## **Technical Evaluation**

**Pinmor Construction, LLC and  
the Dahlia Heights Elementary  
School Classroom Replacement  
Project**

**Contract No. 4400009538**

**25-0310-TE**

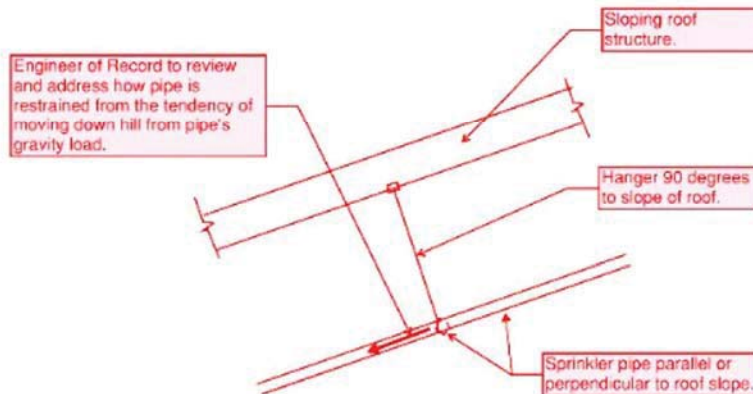
This change order was issued because the hangers for fire sprinkler pipes were proposed to be located at a 90-degree angle to the roof slope and against the gravity load of the pipes (Figure 14). As noted in Finding No. 2 above, the distinct configuration of the roof posed some challenges. The DSA Field Engineer requested that the A/E team review the adequacy of the design of the sprinkler restraint system. FSD's Inspection Department also noticed that the system was not stable and robust. After much deliberation by all parties, the sprinkler restraint system was revised to correspond to the actual slope of the roof and ceiling of the classroom on the second floor (Figure 15).

4. At various locations below the sloping roof, fire sprinkler pipes are following the slope of the roof and the hangers for these pipes are at 90 degrees to the slope of the roof. SEOR to review and address how these pipes are restrained from the tendency to move down hill due to the pipe's gravity load. See sketch below.

**Figure 17. DSA Field Trip Note No. 16– Field Image Note Attachment (June 15, 2023)**

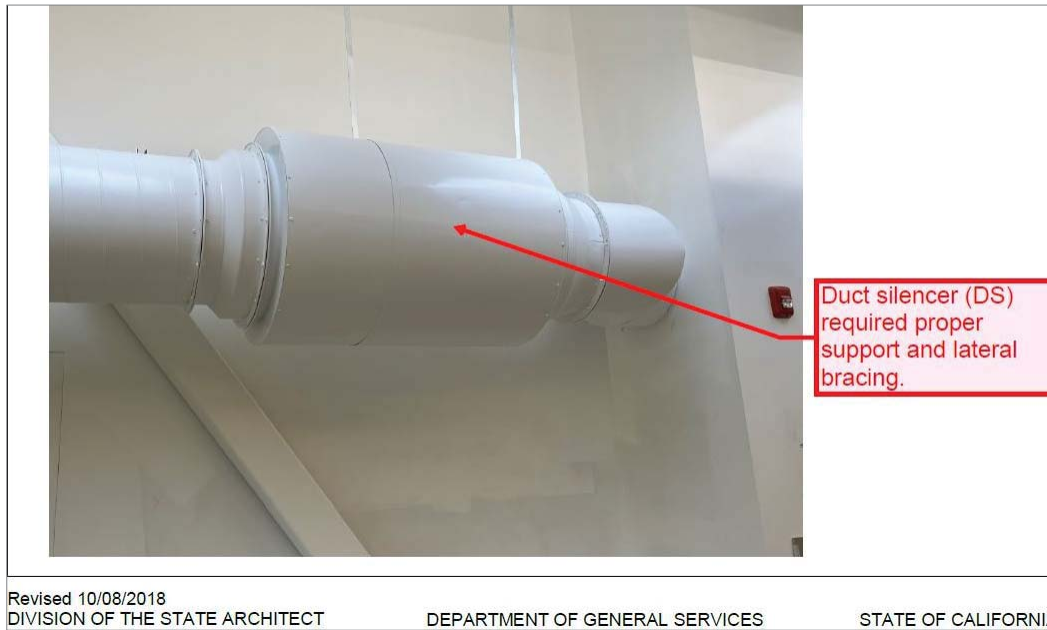
This change order was issued because the mechanical equipment duct silencers on the second floor were installed with only two hanger straps (Figure 17). These duct silencers weighed 220 lbs., so the DSA Field Engineer asked the A/E team to review and verify the adequacy of the hangers, the attachment of the hangers to the duct silencers and to the top connection, the supporting structure to support the duct silencers, and the lateral bracing of the duct silencers. The proposed detail from the mechanical engineer in the construction documents did not address the weight of the duct silencers; therefore, it had to be revised (Figure 18). This issue also resulted in a compensable time delay of 21 days.

Figure 19. Dahlia Heights ES- Level 1 Reflected Ceiling Plan  
Construction Documents Sheet A1.41 Excerpt

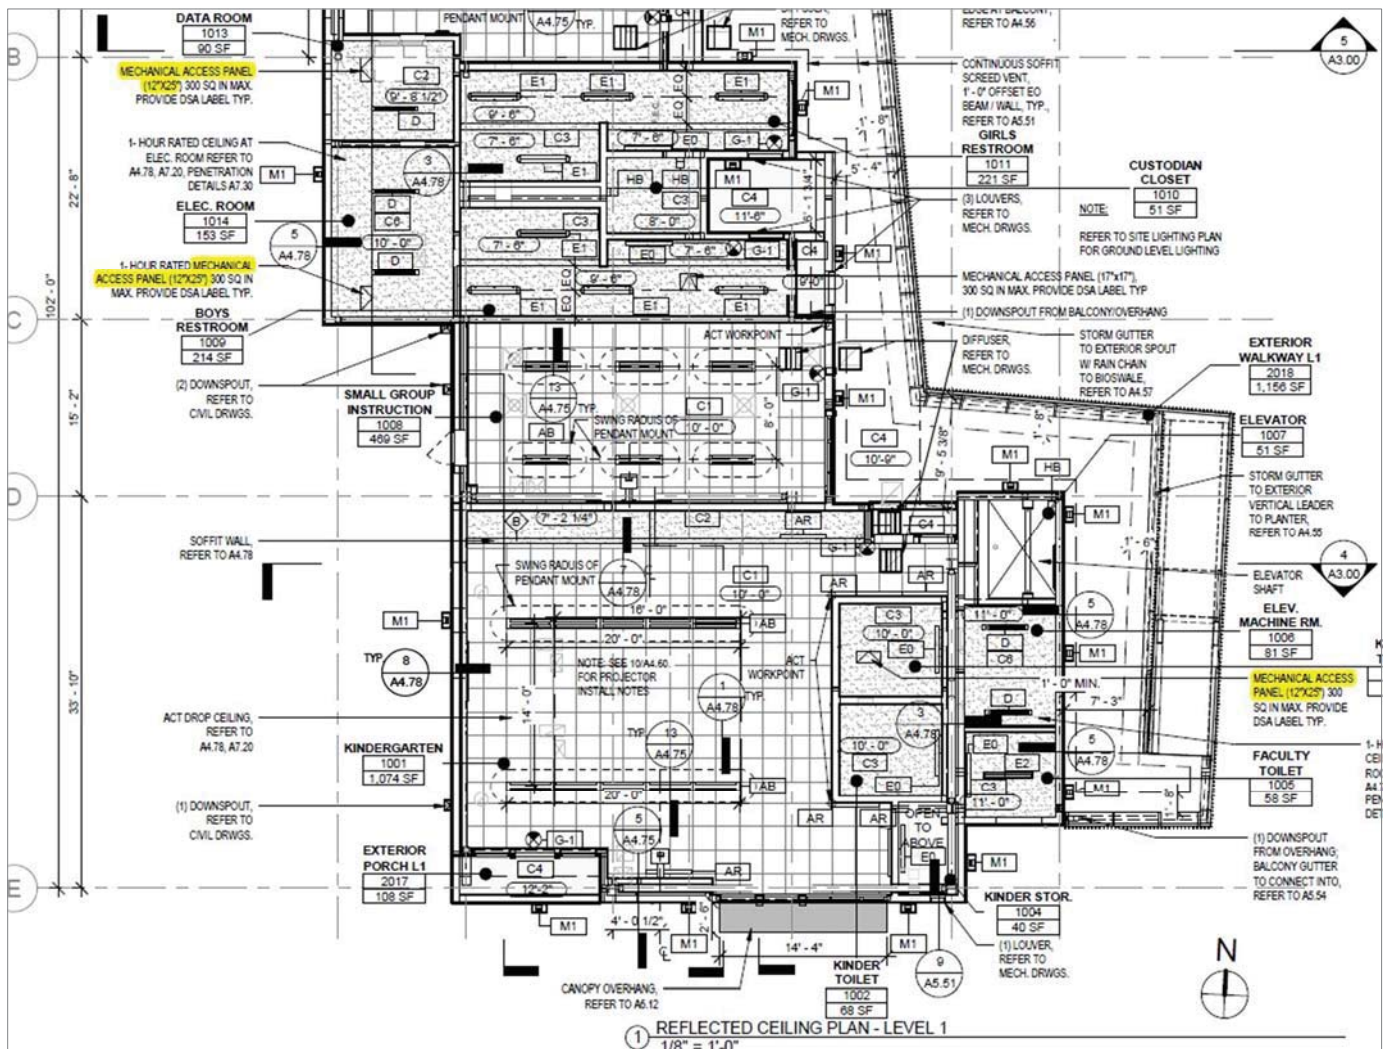
This change order was issued because larger openings were required in hard lid gypsum wall board (GWB) ceilings to allow for the maintenance and replacement of mechanical equipment, as per LAUSD standards. Several of the mechanical access panels were undersized in the construction documents; the reflected ceiling plans show some access panels measuring 12"x 25" (Figure 19). However, project specifications generally required a 24" x 24" access panel door (Figure 20), and the California Mechanical Code required a working space of not less than 30" in depth, width, and height (Figure 21).

**Figure 25. Dahlia Heights ES- View of Southwest Building Exterior Walls  
(OIG Photo - June 25, 2025)**

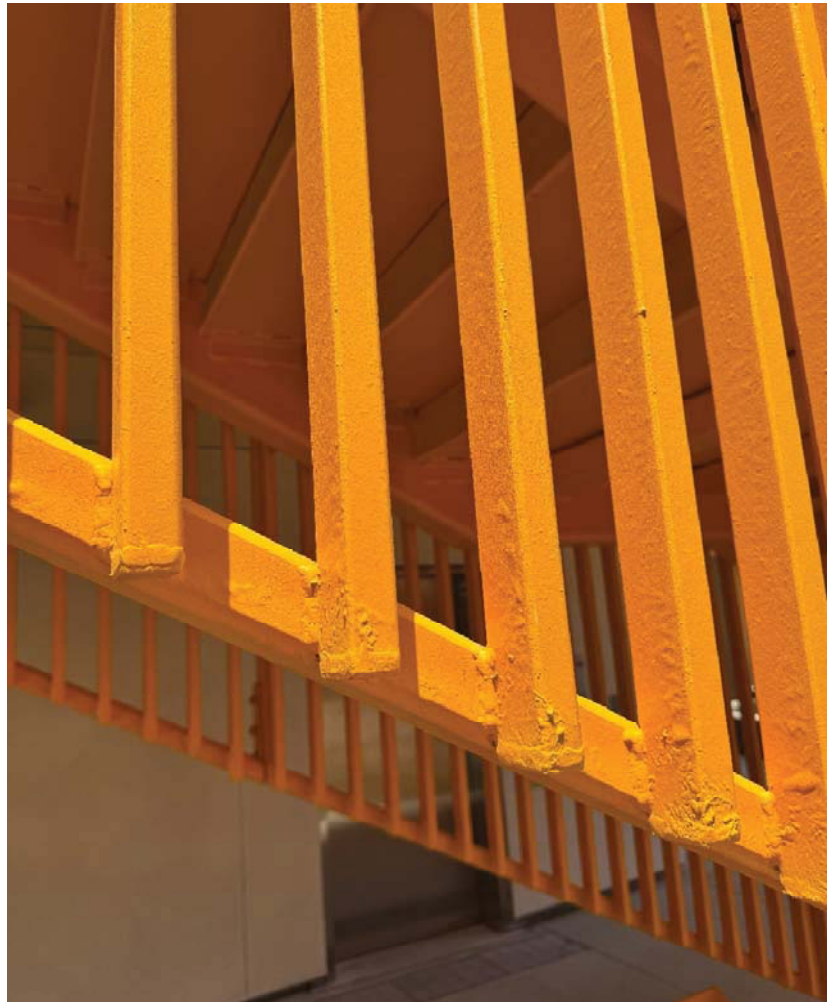
During our site visit on June 25, 2025, we observed that several portions of the steel elements exhibited uneven welded surfaces (Figure 25). This condition appears inconsistent with the contract specifications and visual standards outlined in the project specifications (Figures 26, 27, Pinmor Construction, LLC Page 34 of 65 25-0310-TE Contract No. 4400009538 Dahlia Heights ES-Classroom Replacement Project

and 28). Specifically, the metal fabrication requirements stipulate that all exposed welds must be ground smooth and flush to blend seamlessly with adjoining surfaces. Additionally, the structural steel framing specifications require that exposed fillet welds ½ inch and larger be ground smooth, butt welds be ground flush, and all exposed welds be dressed to meet the standards for Architecturally Exposed Structural Steel (AESS). This requirement was noted in the specification requirements for both metal fabrication and metal stairs and railings. Based on our observations, the current condition of the welded surfaces does not meet these specified aesthetic and fabrication standards.
